APPLICATION NO.	FILING DATE	FIRST NAMED INVENTOR	ATTORNEY DOCKET NO.	CONFIRMATION NO.
10/697,393	10/30/2003	Thomas Holtzman Williams		7468
7590 THOMAS H. WILLIAMS 6423 FAIRWAYS DR LONGMONT, CO 80503			EXAMINER CORRIELUS, JEAN B	
		ART UNIT 2611	PAPER NUMBER	
			MAIL DATE 06/26/2007	DELIVERY MODE PAPER

Interview Summary	Application No.	Applicant(s)	
	10/697,393	WILLIAMS, THOMAS HOLTZMAN	
	Examiner Jean B. Corrielus	Art Unit 2611

Title: DIGITAL TRANSMISSION SYSTEM USING NON-ORTHOGONAL MATRICES

RESPONSE TO OFFICE ACTION

FIG 1
(PRIOR ART)

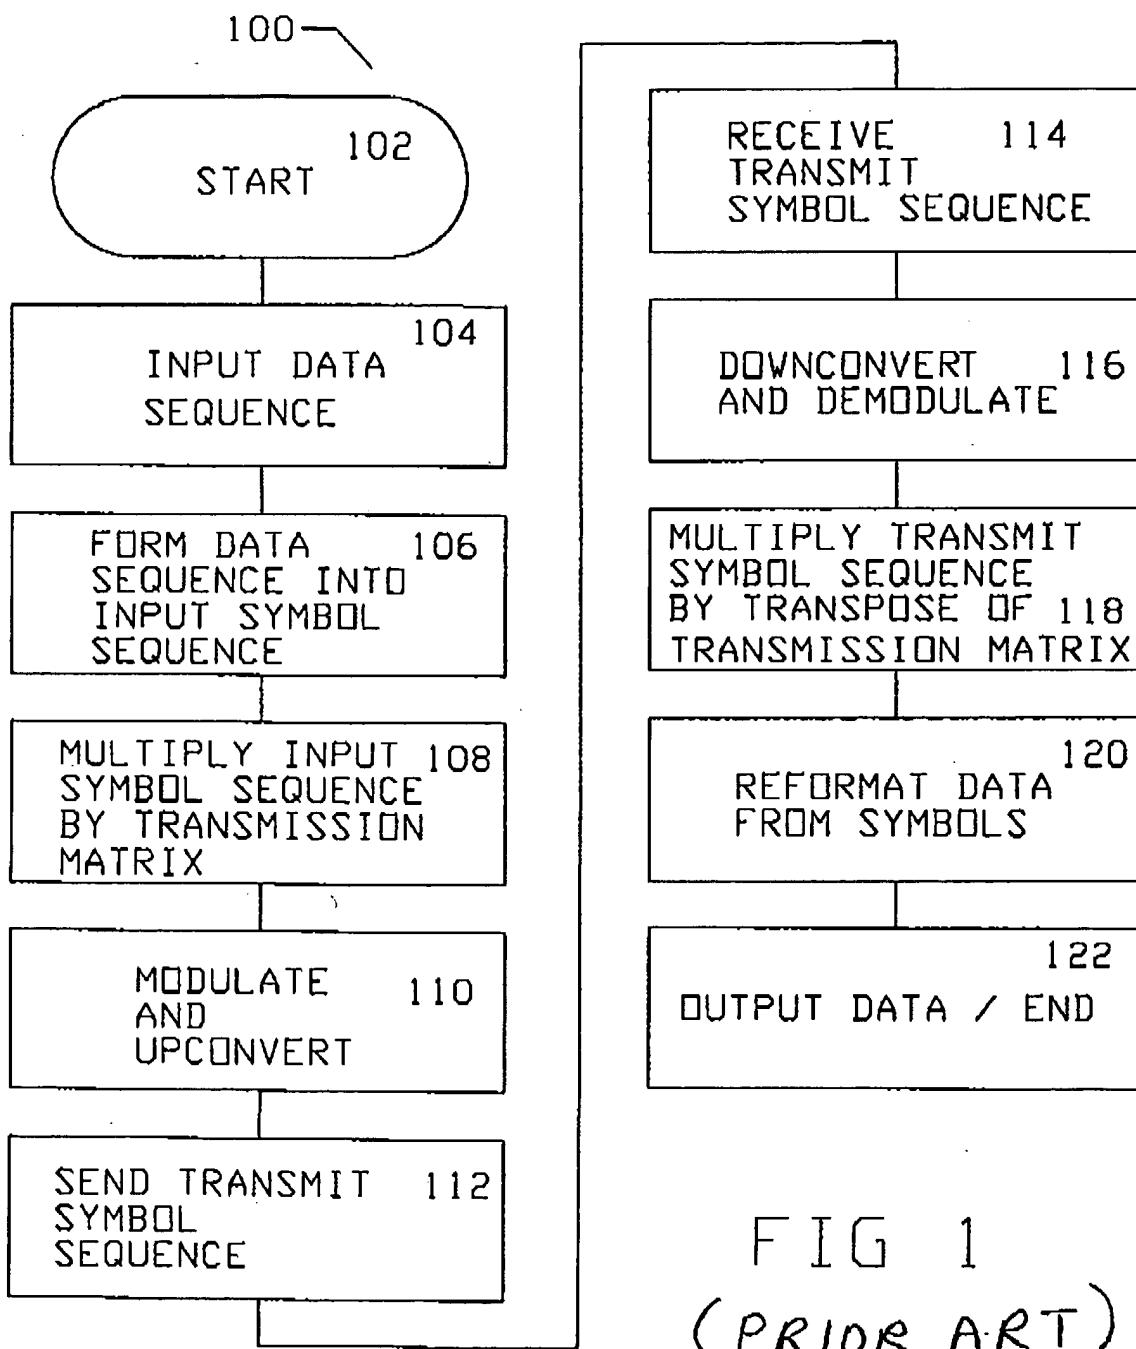
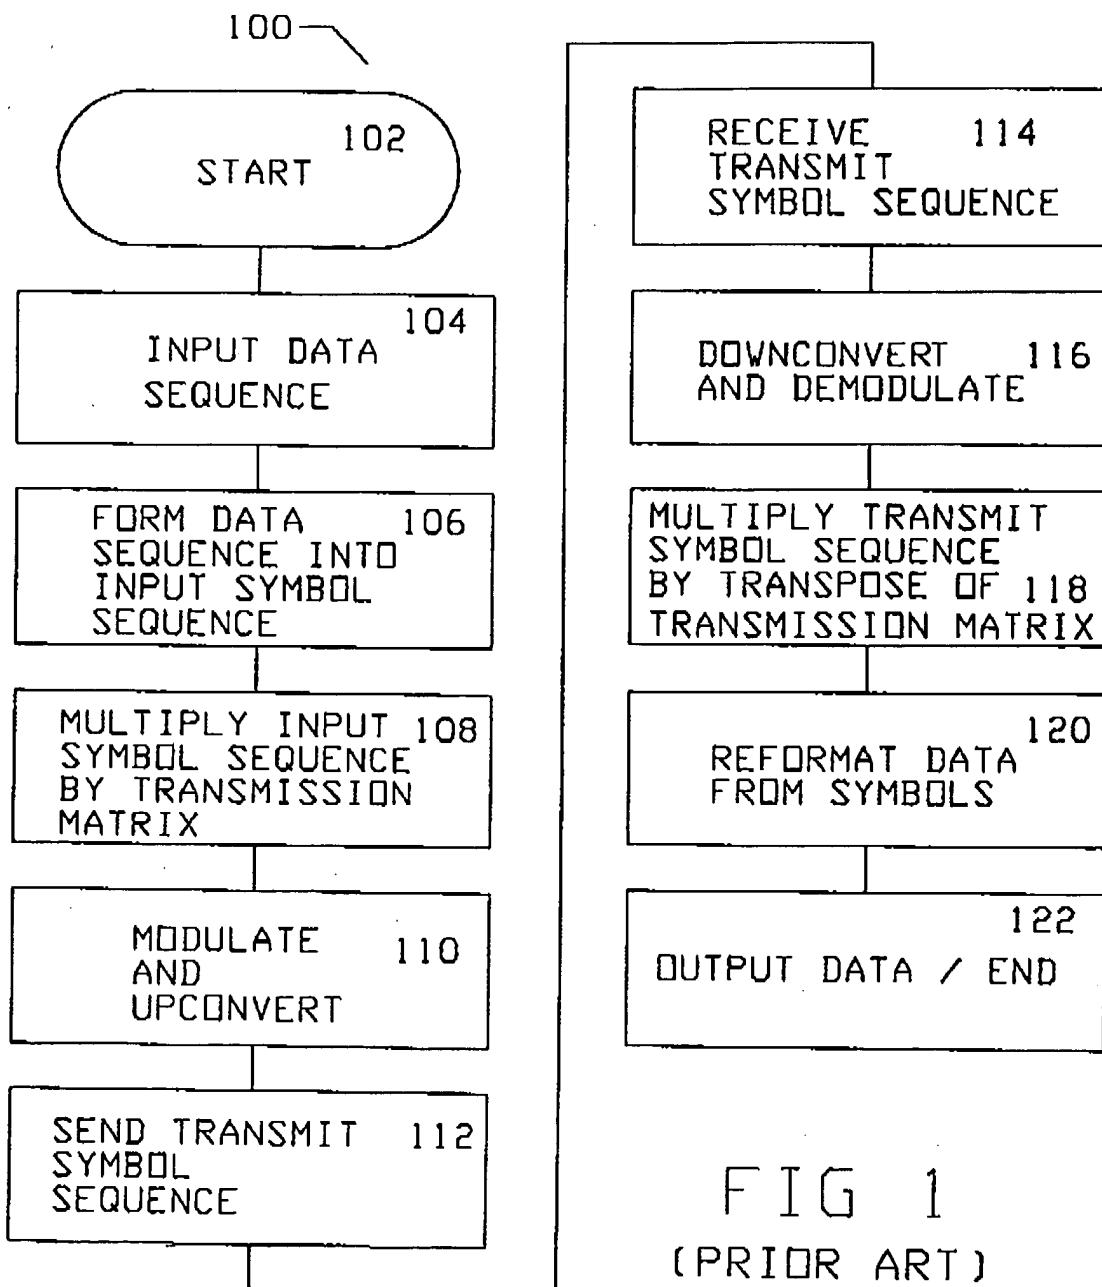
Claims 1-8 were rejected under 35 U.S.C. 103(a) as being unpatentable over applicants admitted prior art fig. 1 in view of Kuchi et al US Patent No. 7,006,579.

"(PRIOR ART)" is be added underneath "FIG 1" in a replacement sheet FIG 1.
